UNITED STATES PATENT AND TRADEMARK OFFICE

APPLICATION NO.	FILING DATE	FIRST NAMED INVENTOR	ATTORNEY DOCKET NO.	CONFIRMATION NO.
10/820,648	04/08/2004	Ata Zadehgol	P18563 (INTEL29)	8505
6980	7590	07/28/2005	EXAMINER	
TROUTMAN SANDERS LLP BANK OF AMERICA PLAZA, SUITE 5200 600 PEACHTREE STREET, NE ATLANTA, GA 30308-2216				GLENN, KIMBERLY E
		ART UNIT		PAPER NUMBER
		2817

Office Action Summary	Application No.	Applicant(s)
	10/820,648	ZADEHGOL ET AL.
	Examiner Kimberly E. Glenn	Art Unit 2817

DETAILED ACTION

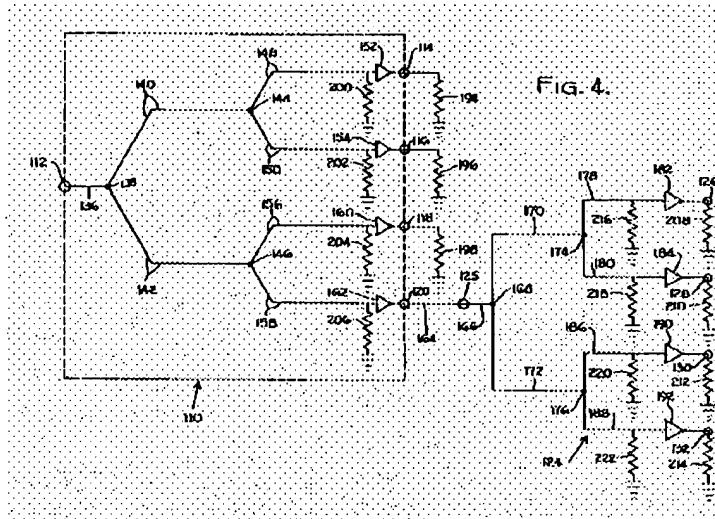
Claims 1-4, 7-12, 14-16 and 19-28 are rejected under 35 U.S.C. 103(a) as being unpatentable over Barczys US Patent 4,885,557 in view of Abouzahara et al US Patent 4,947,143.

Barczys disclose in figure a first multicoupler 100 connected to an input signal 112 and having a first output 118 and a second output 120; a termination resistor 204 connected to the first output and second multicoupler connected to the second output 120 and having a plurality of outputs. A plurality of amplifiers are connected to the plurality of outputs. The amplifiers are connected to matching resistors. Inherently, transmission lines connected between the amplifier and the matching resistors.

Thus, all the limitation of the claims are shown with the exceptions of the output having equal phase and equal magnitude, the pie type impedance matching body section having a wedge shaped geometry and the pie type impedance matching section comprising a conductive material.

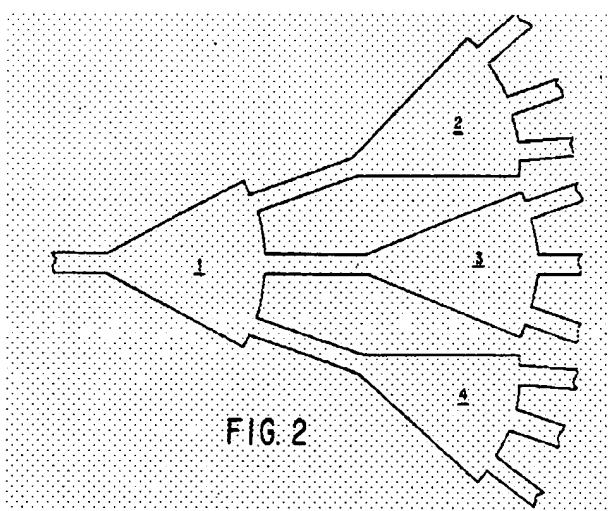
or "pie" Abouzahara et al disclose in figure 2 a fan shaped divider/combiner comprising a plurality of ports (1-4). Abouzahara et al disclose in the abstract the planar configuration provides to a balanced phase and amplitude outputs.

One of ordinary skill in the art would have found it obvious to replace the multicoupler of Barczys with the divider/combiner as taught by Abouzahara et al since the examiners takes notices of the equivalence of the multicoupler and the divider/combiner for their use in the a transmission line art and selection of any these known equivalents to provide a splitting means would be within the level of ordinary skill in the art.
